Access Compliance Report

Public Rights-of-Way (Curb Ramps)

| Intersection ID: 10029698 | Main Street: KINGSTON_FOREST_DR | Cross Street: N/A | Location: SW |
| ADA ID: 51ED4B341CC1 | Ramp Type: Perp | Initial Pass/Fail: Fail | Overall Compliance: No |

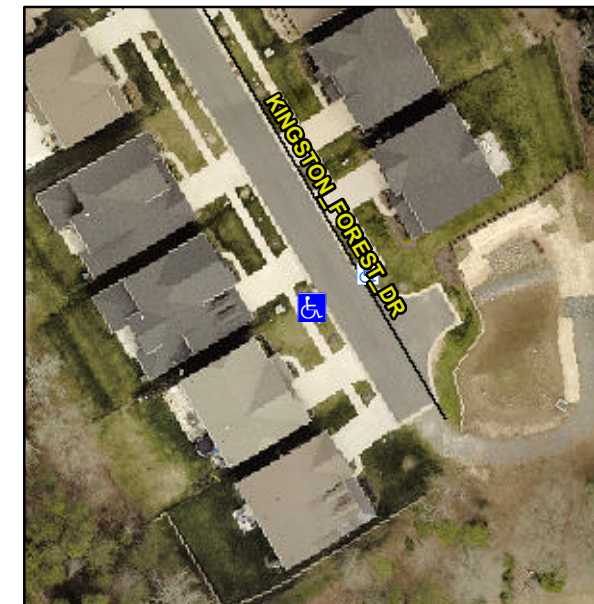
Not Found, R304.5.1

| Compliance | Description | Data | Compliance | Description | Data |
|------------|-----------------------|-------|------------|-----------------------------|------|
| No | Ramp Width (in) | 46.5 | Yes | Ramp XSlope (%) | 0.3 |

Remove & Replace Entire Ramp.
